## Submissions and Amendment Report

SSD 9835 – Sydney Football Stadium Stage 2

Modification 7 – Precinct Village and Car Park

Submitted to NSW Department of Planning,  
Industry and Environment

**Figure 7** Raised plaza level and access ramps (exhibited left, proposed right)

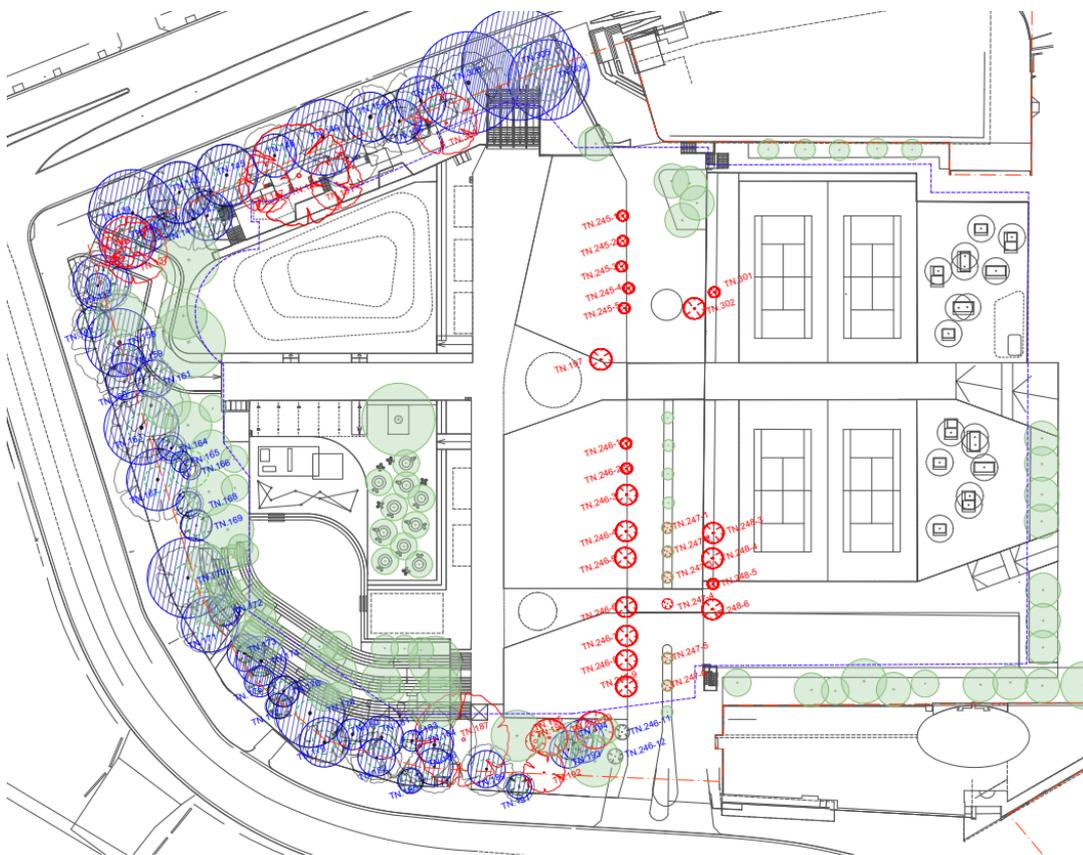
- Replacement of the previously proposed green planted edge roof on the tennis club with pebbles in an artistic pattern.
- Raising of the plaza level on the eastern concourse to accommodate existing underground services and maintaining the head height for outside broadcasting compound area, while separating ramps for pedestrians and vehicles with different gradients to maintain DDA compliance.

- Replacement of the previously proposed green planted edge roof on the tennis club with pebbles in an artistic pattern.
- Raising of the plaza level on the eastern concourse to accommodate existing underground services and maintaining the head height for outside broadcasting compound area, while separating ramps for pedestrians and vehicles with different gradients to maintain DDA compliance.

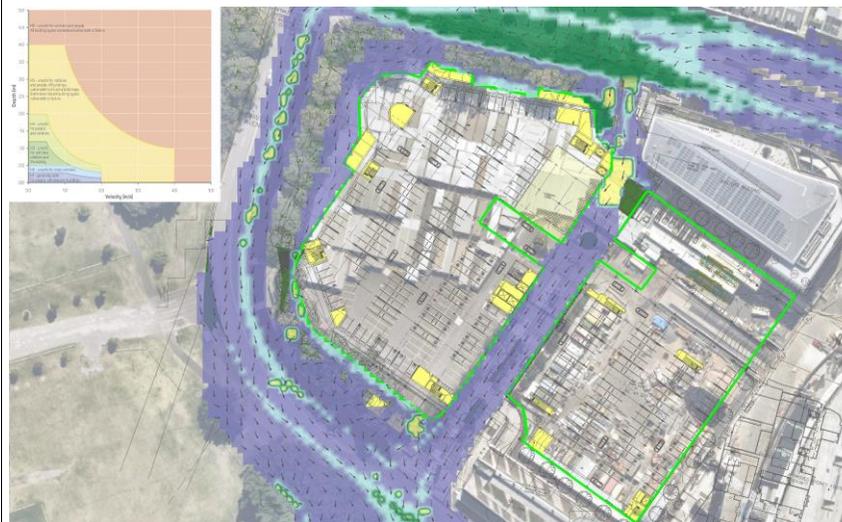
Further design work is recommended to ensure the safety of future road users. Otherwise, the proposal may result in a significantly increased requirement for government spending on emergency management services, flood mitigation and emergency response measures. A similar issue is present along the Moore Park Road frontage, where very high flood depths (deeper than one metre) are predicted under proposed conditions.

A design should be developed to demonstrate this will not create a new and very dangerous hazard for pedestrians. A dedicated overland flow path could be created.

In relation to the carpark entries, as noted in Section 8.3 of the Precinct Village and Car Park (MOD 7) Stormwater and Flooding Assessment (September, 2021), the concept design provided permanent protection from 1% AEP overland flows grading of the central road. Flood gates were only included to provide protection beyond the 1% AEP up to the greater of the 1% AEP plus 500mm freeboard or PMF level, as required by the *City of Sydney Interim Floodplain Management Policy* for entries connecting to basements. As noted in the response to the previous comment, as part of ongoing design development the central driveway has since been lowered to remove the requirement for flood gates.

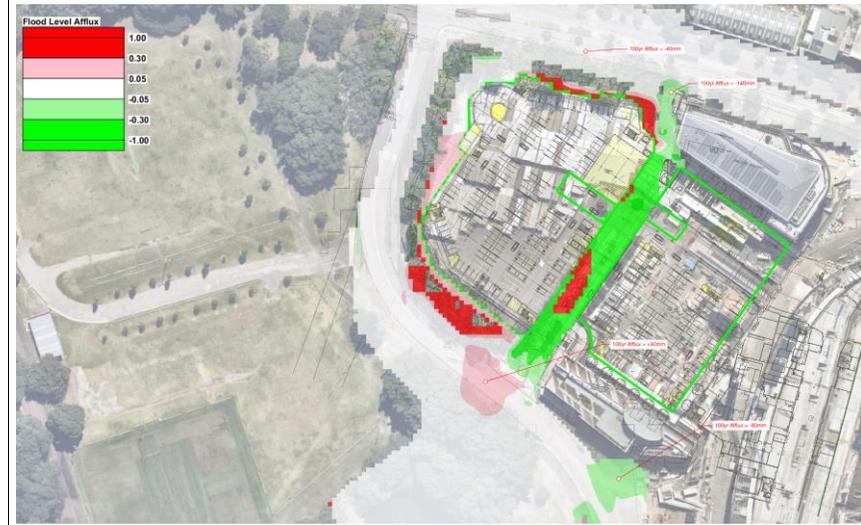
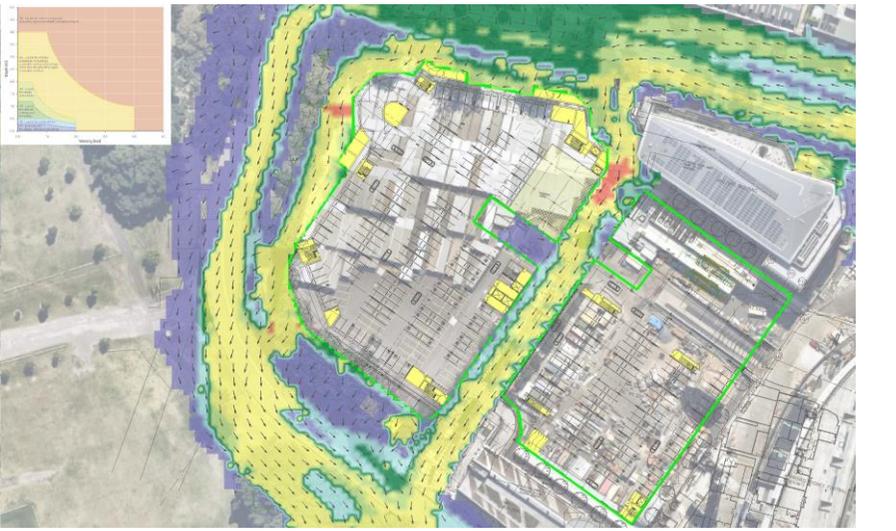
Clarification is requested around the flood impact maps. Figure 8 is titled 1% AEP flood depth afflux map, while in Appendix A, Figure 004 is titled Peak Flood Level Change. The two figures appear to show the same information, and flood level impacts are the more robust measure of change. The consultant could justify using depth impacts if necessary and assuming depth impacts have not been used to mask true impacts.

EES raises concerns around flood impacts to Driver Avenue. The Precinct Village and Car Park (MOD 7) Stormwater and Flooding Assessment, dated 6 September 2021, states flood levels would increase up to 50mm. However, the predicted impacts, as per Figure 8 of the Stormwater and Flooding Assessment shows up to a 0.3m increase in flood levels. This should be clarified.

Regardless, a 50mm increase is a significant adverse impact, well beyond the commonly accepted limit of 10mm. Notably, the highest increase occurs where the existing flood risk is greatest, exacerbating these conditions. EES recommends the applicant introduce mitigation measures to avoid worsening existing flooding conditions. Alternatively, the change in hazard category (H1-H6) could be mapped to assess if there is a significant change in hazard.

To provide clarification around the flood impact maps provided in the report, Arup confirm that both Figure 8 and Appendix A, Figure 004 display flood level afflux – the title of Figure 8 is incorrect and should read “Figure 8: 1% AEP flood level afflux map”.

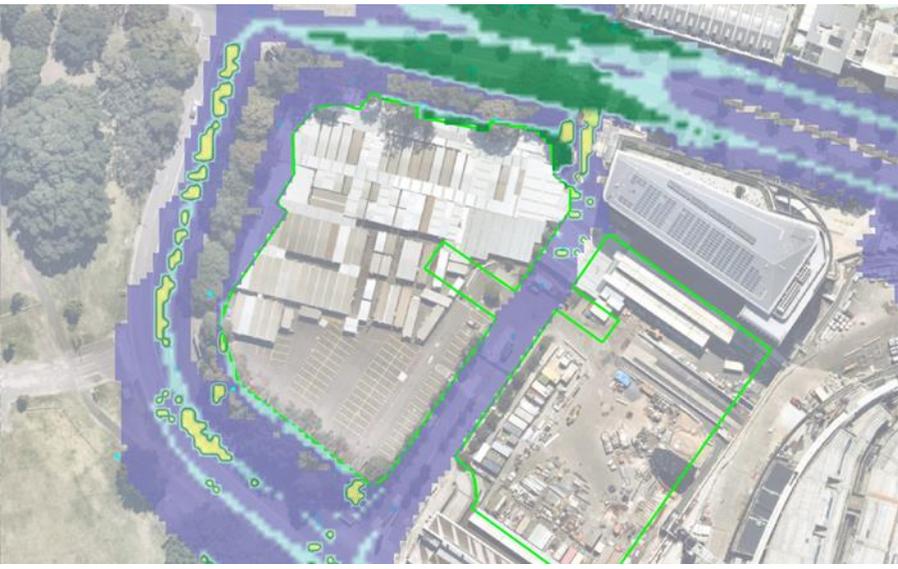
| Issue Raised   | Applicant Response   |
|--|--|
| <p><i>Stormwater</i></p> <p>Overland flow and localised flooding in 1 in 100 year storms are an issue on the northern edge of western car park basement. Storm water is to be channelled around the site.</p> <p>Architect section L (dwg A42.00.20 [B]) shows a stormwater culvert at the edge of the carpark located over the top of carpark plenums. It is queried whether stormwater and air intake can be mingled and clarification on this is requested.</p>   | <p>The afflux for the 100 year event shows the changes to the overland flow on the western side of the stage 2 development are localised, further development of the design with respect to the mechanical risers and the stormwater diversion is underway.</p>    |

| Issue Raised   | Applicant Response   |
|--|--|
|  | <p>The hazard in the 100 year solution for the western side remains H1 which is acceptable.</p>  |
